REGIONAL REVIEW NOTIFICATION

Name of Proposal: 990-1008 Brady DRI 3674 Submitting Local Government: City of Atlanta

<u>Description</u>: A DRI review of a proposal to construct a mixed-use project on a previously developed 3 acre site on the west side of Brady Avenue north of 10th Street in the Upper Westside in the city of Atlanta. The project will include approximately 700 multifamily residential units, 300,000 SF of office, and 50,000 SF of ground floor retail.

BRADY DRI City of Atlanta Natural Resources Group Review Comments July 11, 2022

Stream Buffers

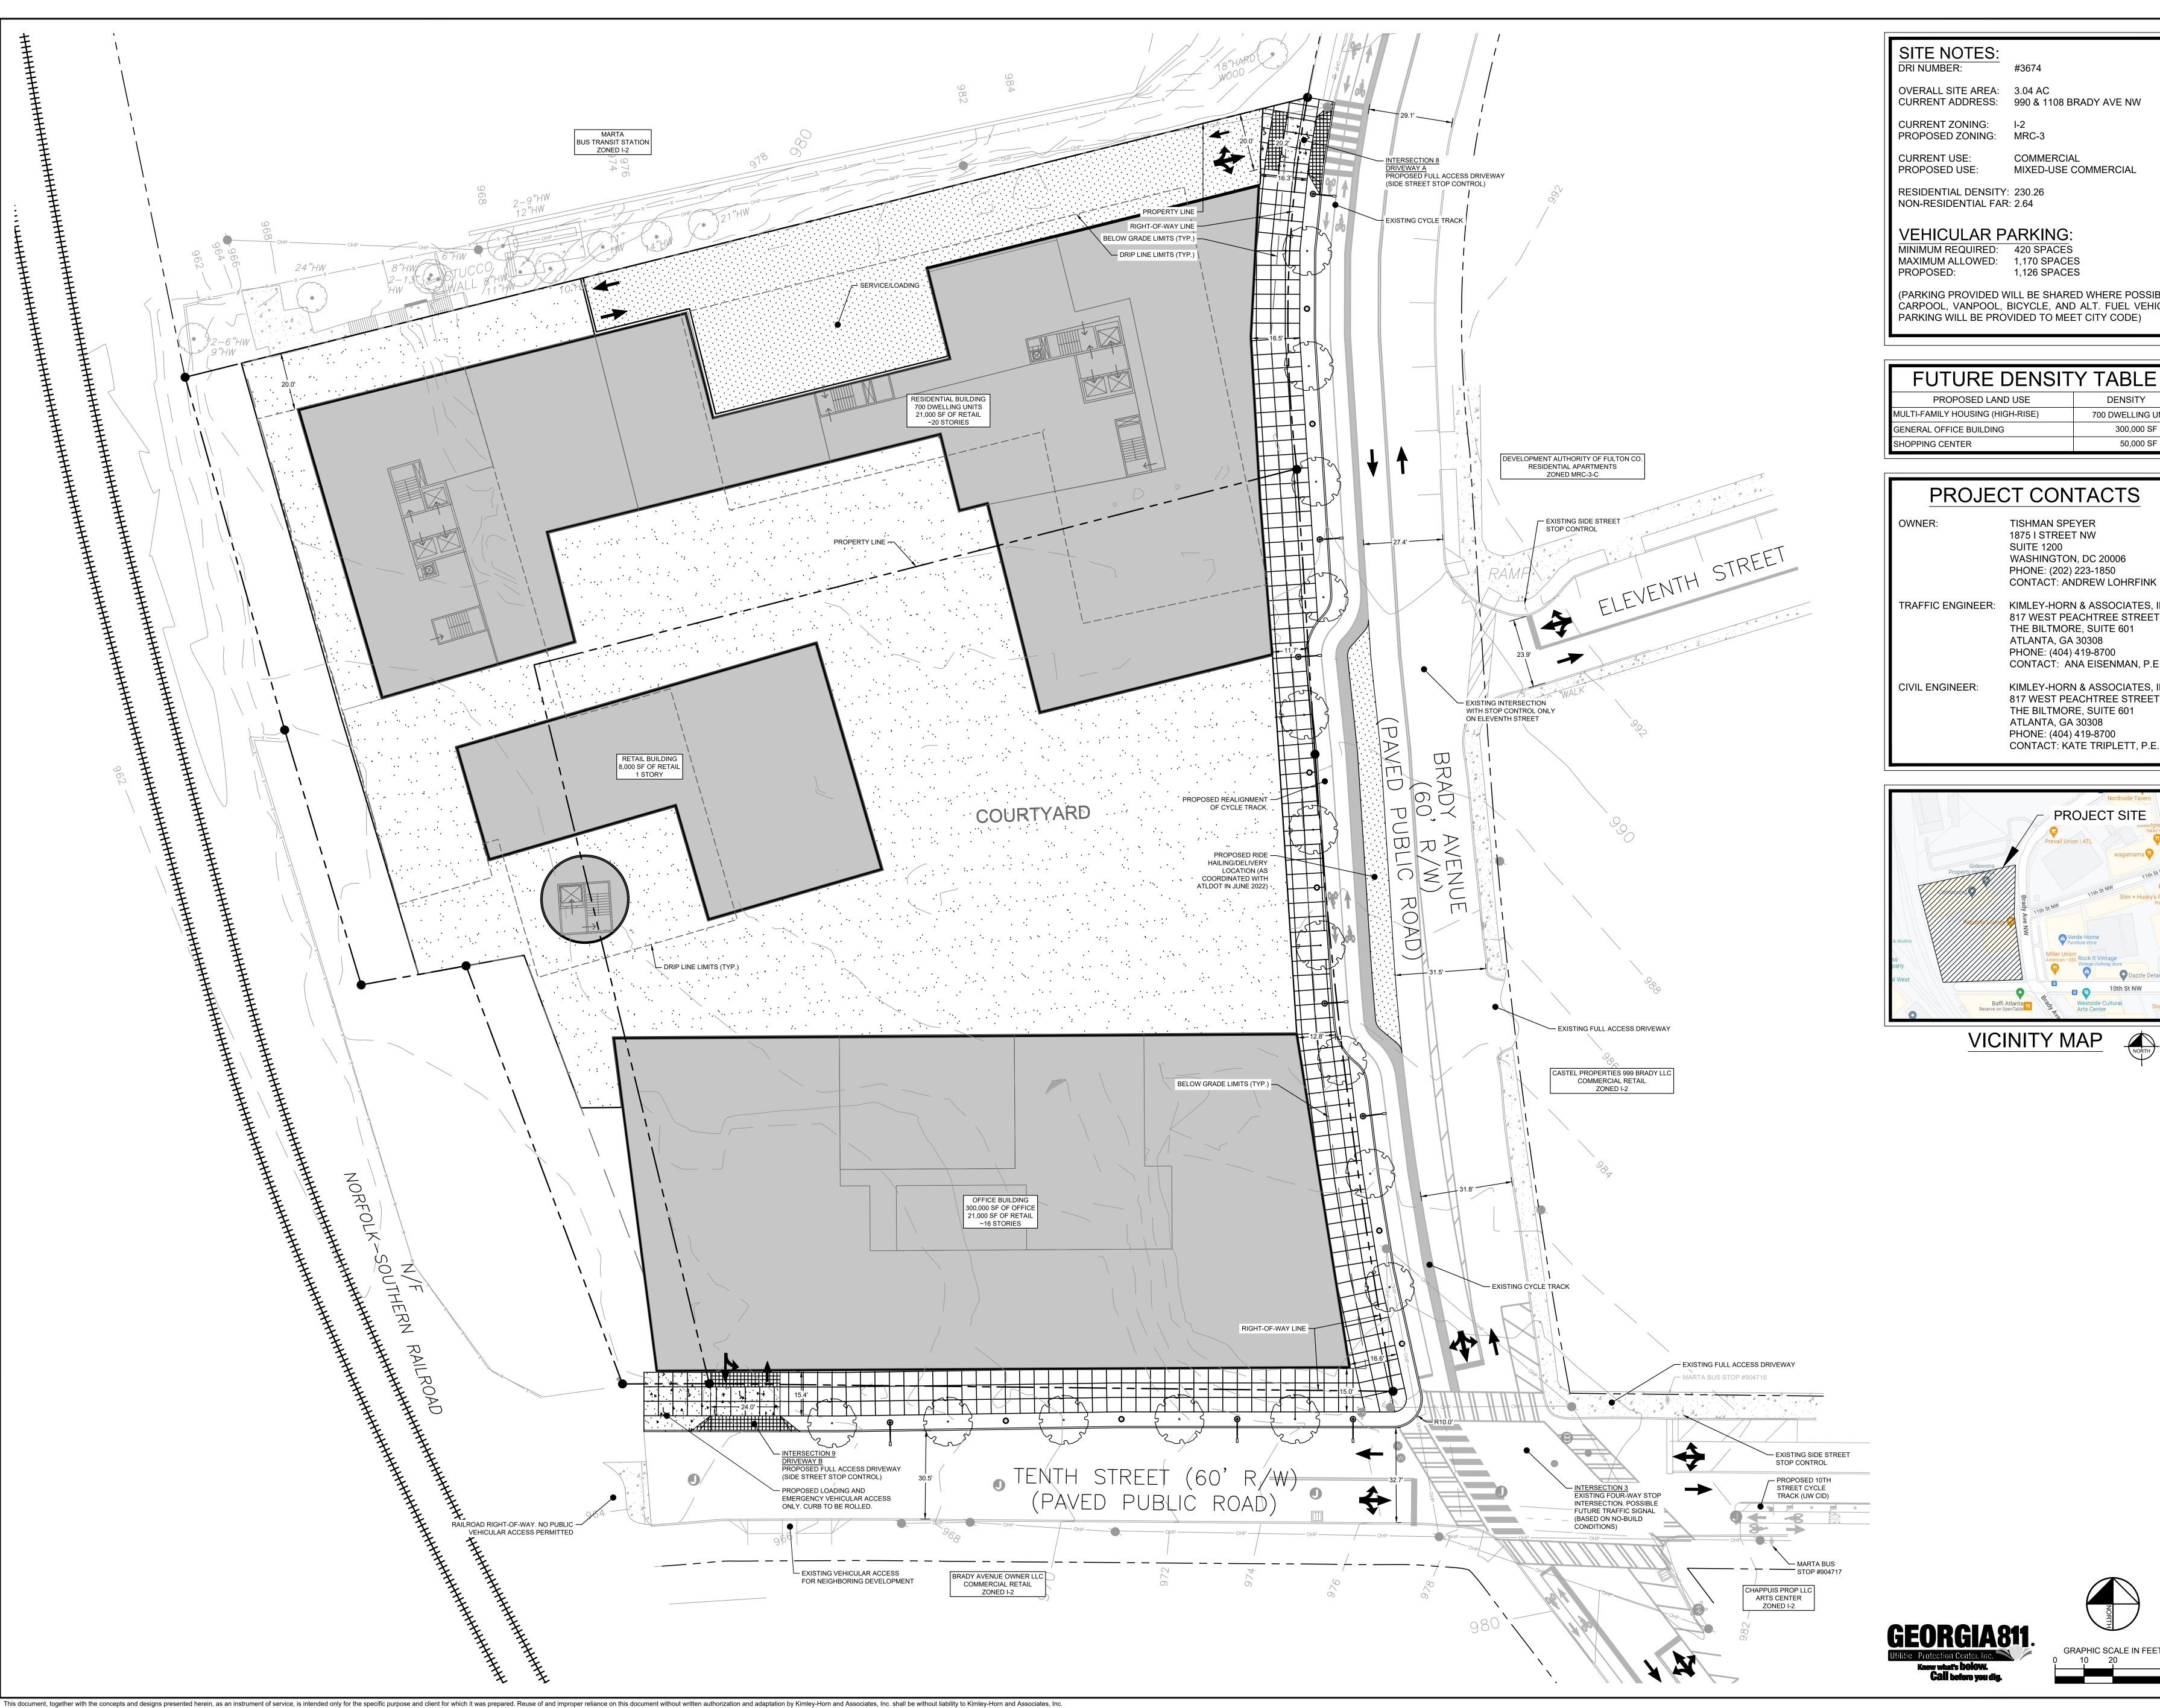
The USGS coverage for the project area shows no blue-line streams on or near the property, and none are shown on the submitted site plan. Any unmapped streams on the property may be subject to the requirements of the City of Atlanta's Stream Buffer Ordinance. Any unmapped waters of the State on the property may subject to the 25-foot State Erosion and Sedimentation Act buffers.

COURTYARD **LEVEL DRI #3674**

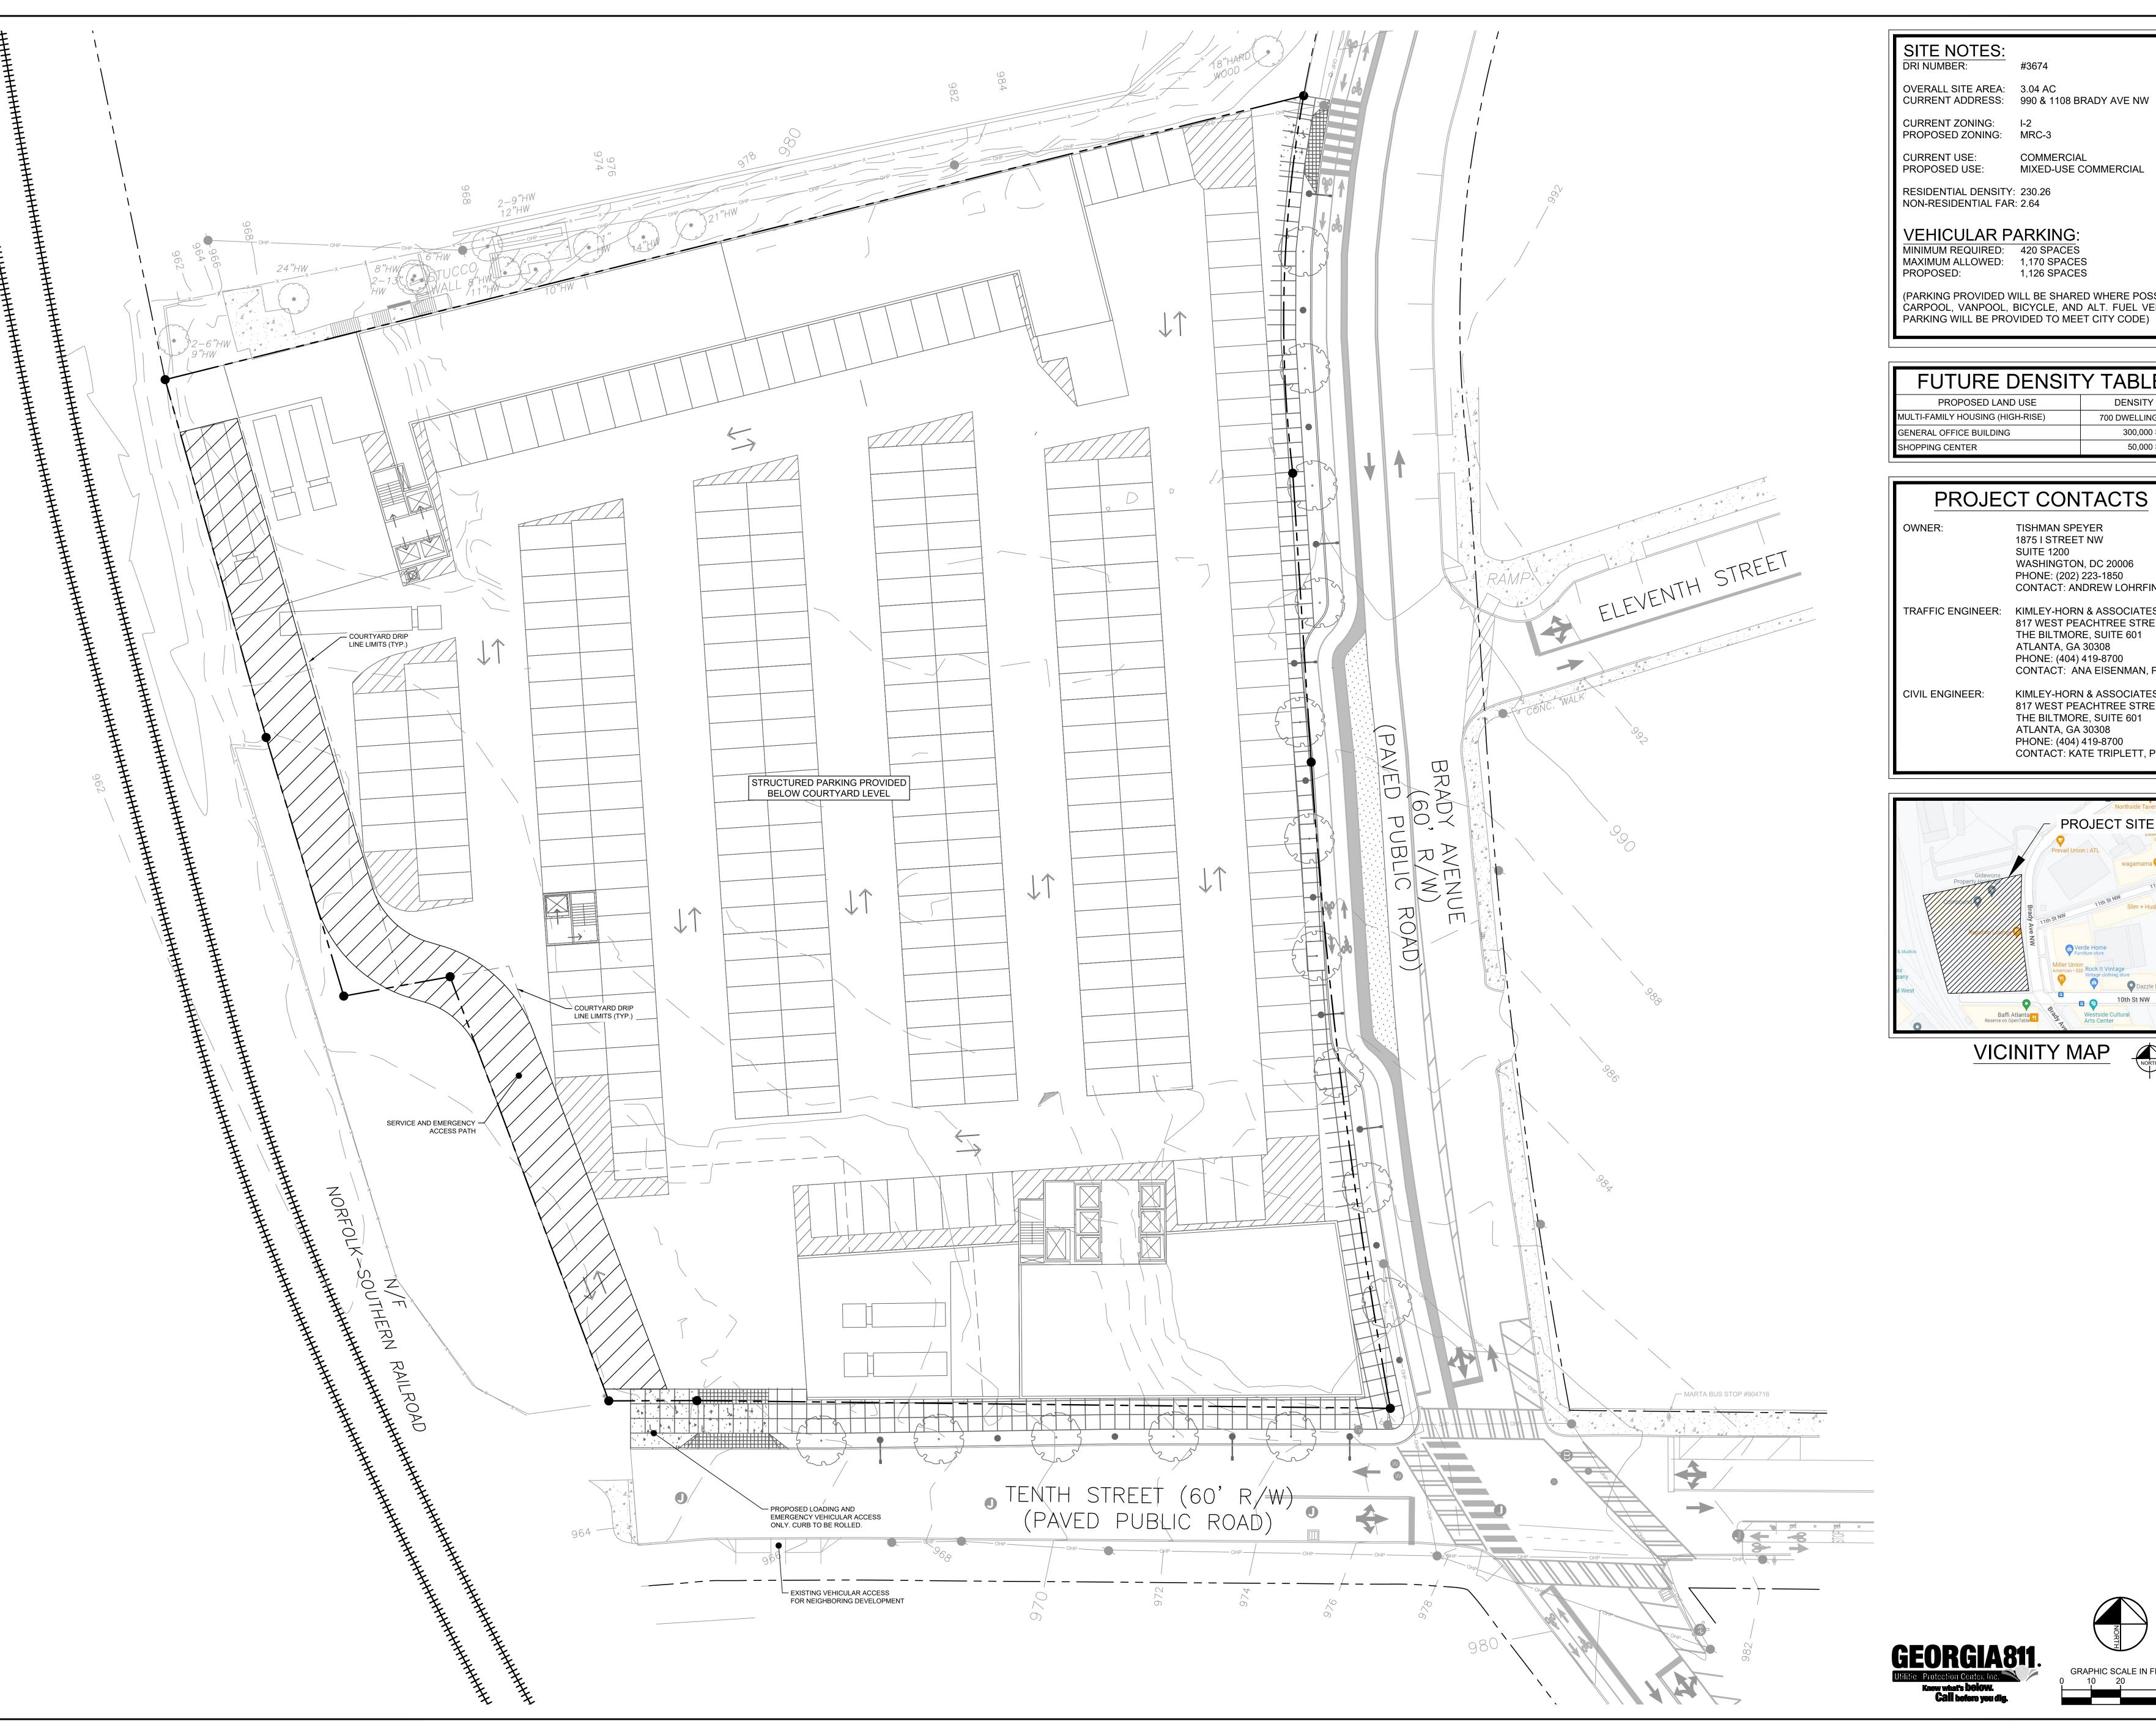
The proposed 950 space underground parking garage allows for an active street level courtyard which avoids the challenge of integrating a parking podium into the design and directly advances placemaking and walkability policies.

Care should be taken to ensure that the constructed development provides an interconnected, functional, clearly marked and comfortable pedestrian experience on all driveways, paths, entrances, and parking areas. To the maximum extent possible, new driveways and intersection corners where pedestrians will cross should be constructed with minimal curb radii to reduce speeds of turning vehicles and decrease crossing distances for pedestrians.
